ROADSTER 2016 Brake Fluid Reservoir Locking Tube - 129289

All MY 2016 built from January 26th have now a brake fluid reservoir locking tube.

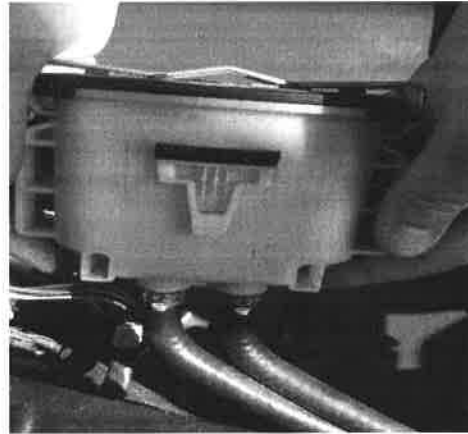
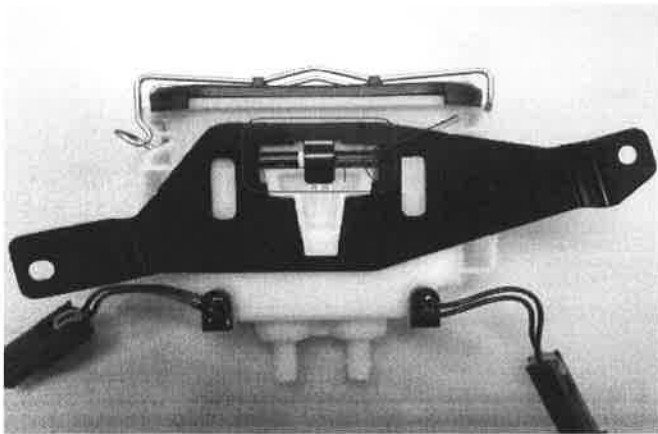
We have found that brake fluid reservoir can unclip by itself. An improvement to avoid that has been done to keep it in place and lock it. All roadster built after Jan. 26th of 2016 will have this locking tube. Note that all 2015 F3 have this reservoir type, so it is recommended to install this tube when servicing units. This locking tube has been added on the electronic parts catalogue for MY 2016.

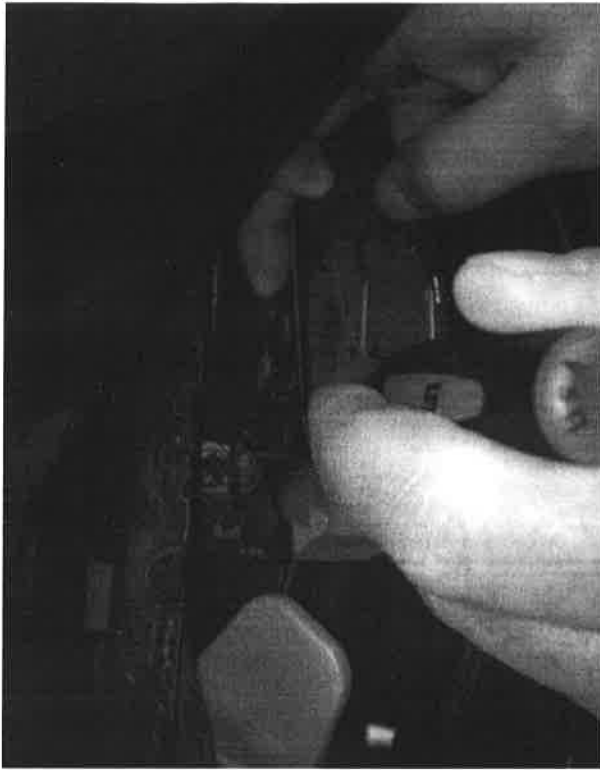
When servicing a unit, simply use a 90 degrees hook and carefully pry tube just a little to clear bracket. Then use your finger to push it and remove it.
